London Luton Airport Expansion

**8.50 Applicant's Post Hearing Submission - Issue Specific
Hearing 4 (ISH4)**

Application Document Ref: TR020001/APP/8.50

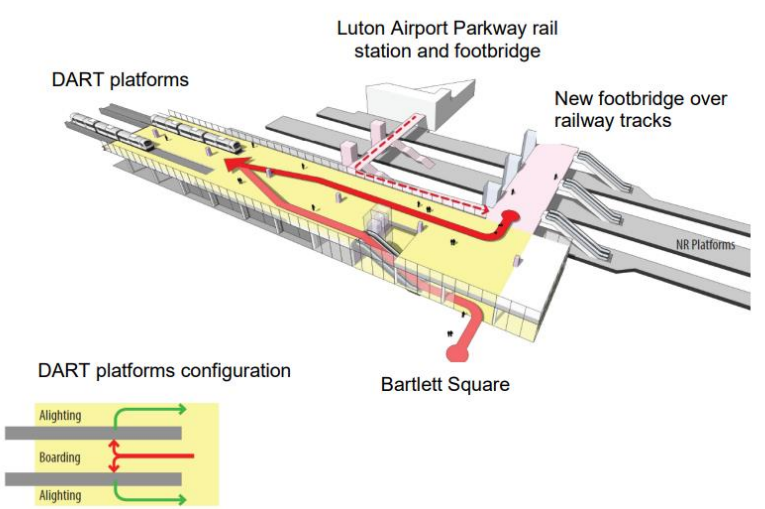
Action	Description	When	Applicant's response
	Proposed Development (and no junction improvements) 3. and then with Proposed Development and the proposed highway improvements. This will need to be done for each of the assessment phases.		
10	Confirm whether the zebra crossing to Queen Elizabeth School was included in the assessment of the proposed signalised junction at Lalleford Road and Crawley Green Road. If not, why not and should it be?	D3	<p>The operation of the proposed signalised junction at Lalleford Road and Crawley Green Road was assessed using the Luton DCO VISSIM model.</p> <p>The zebra crossing to Queen Elizabeth School was not explicitly included within the Luton DCO VISSIM model given that the crossing is located over 60m from the location of the Lalleford Road/Crawley Green Road junction and in general was not considered to interact with the crossing. Whilst not explicitly modelled, the influence of the crossing would be accounted for in the base model validation which considers journey times and junction operation.</p> <p>Further information on the approach is provided below.</p> <p>The zebra crossing on Crawley Green Road connects the residential areas to the south with the Queen Elizabeth School to the north. The main demand for the crossing would therefore occur between 8am and 8:30am when the school opens, and at the end of the school day at 3pm. Outside these times, demand would likely be low which means the PM peak modelling would be unaffected.</p> <p>The zebra crossing is located approximately 65m west of the give way line at the existing Crawley Green Road/Lalleford Road mini roundabout. This distance would accommodate a queue of circa 11 vehicles, assuming 6m per vehicle.</p>

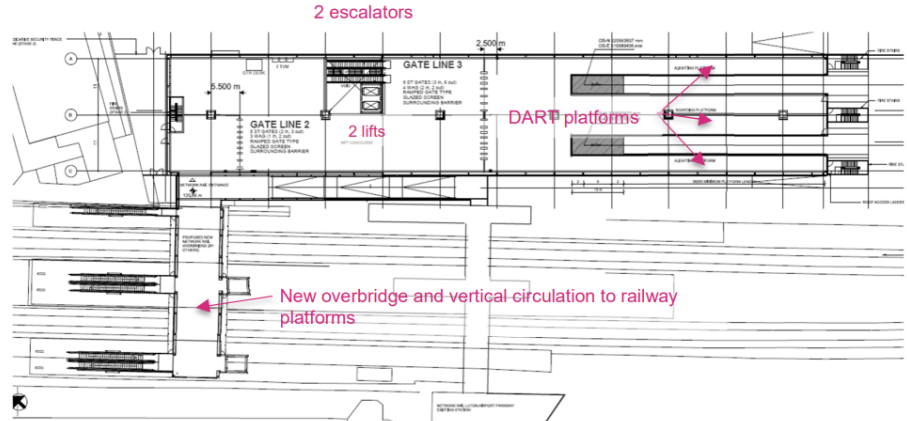
Action	Description	When	Applicant's response
			<p>Traffic movements along Crawley Green Road and Lalleford Road were validated on the basis of the turning movements at junctions along the corridor. The validation of the model turning movements against the survey data for the Crawley Green Road/Lalleford Road junction- as well as upstream and downstream junctions, including the Crawley Green Road junctions with Ashcroft Road and Wigmore Lane and the Lalleford Road/Eaton Green Road junction- indicates that the journey time along the corridors was representative of the observed AM and PM peak conditions.</p> <p>As part of the Proposed Development, the Crawley Green Road/ Lalleford Road junction would be upgraded to a signalised junction which would slightly reduce the distance between the junction stop line and the zebra crossing to circa 61m. This means that there was space for circa 10 vehicles to queue at the stop line.</p> <p>Traffic modelling in Table 10.131 of the Transport Assessment [APP-205] shows that the average modelled queues in the 2043 full development network peak hours are well within the available storage space between the junction and crossing. Whilst the maximum queues do extend back to the crossing, these are intermittent and do not affect the overall operation of the crossing or conversely the junction.</p> <p>It is also noted that the junction improvement incorporates a new pedestrian crossing on the eastern arm of Crawley Green Road, which potentially serves some crossing movements that might otherwise have occurred at the zebra crossing.</p>
